Request for Air Pollution Control Board hearing on Chickahominy Power

APPLICANT NAME AND REGISTRATION NUMBER: Balico LLC; 52610 FACILITY NAME AND ADDRESS: Balico LLC/Chickahominy Power, 1380 Coppermine Rd. Ste.115, Herndon, VA 20171

Balico LLC/Chickahominy Power

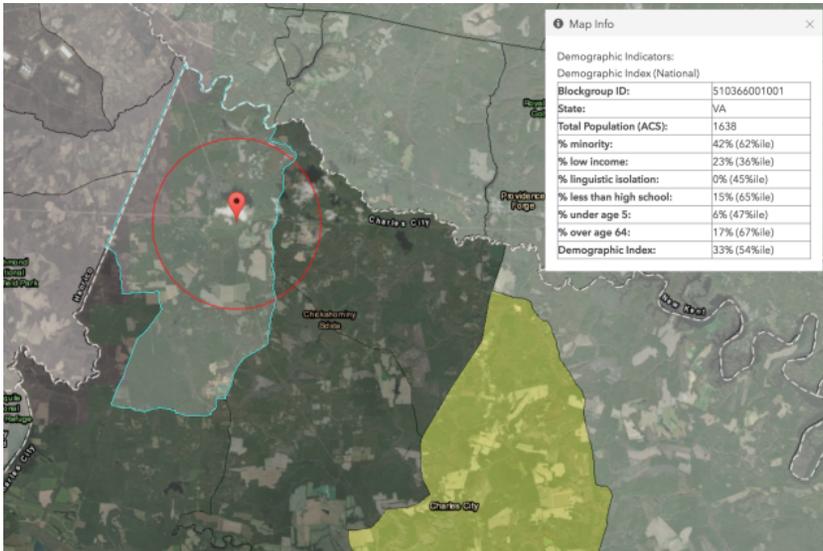
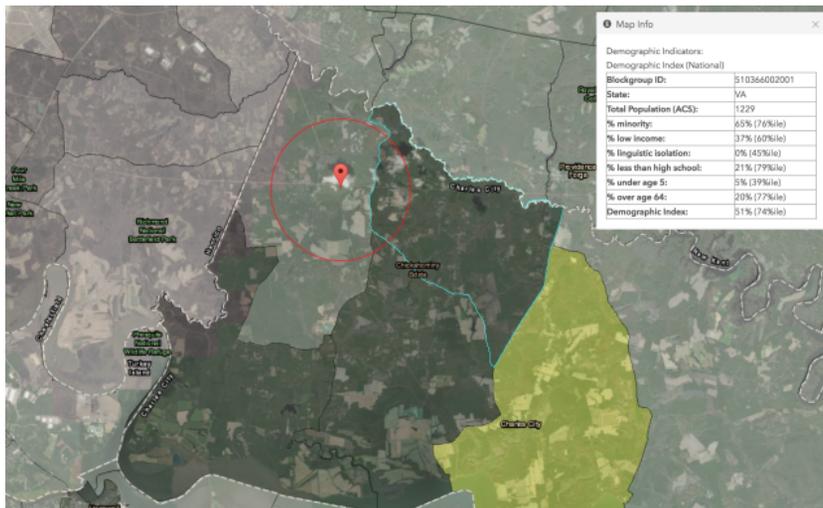
The proposed plant is located in census tracts (shown below) that are 42% and 65% minority, requiring analysis of the populations located closest to the facility to assure there is not an even higher cluster that might be hidden in the aggregated data at the census tract level. Existing industry around this site demonstrates the need to consider to existing burden of hazardous pollutants so as to not avoid disproportionately impact to marginalized or vulnerable populations.
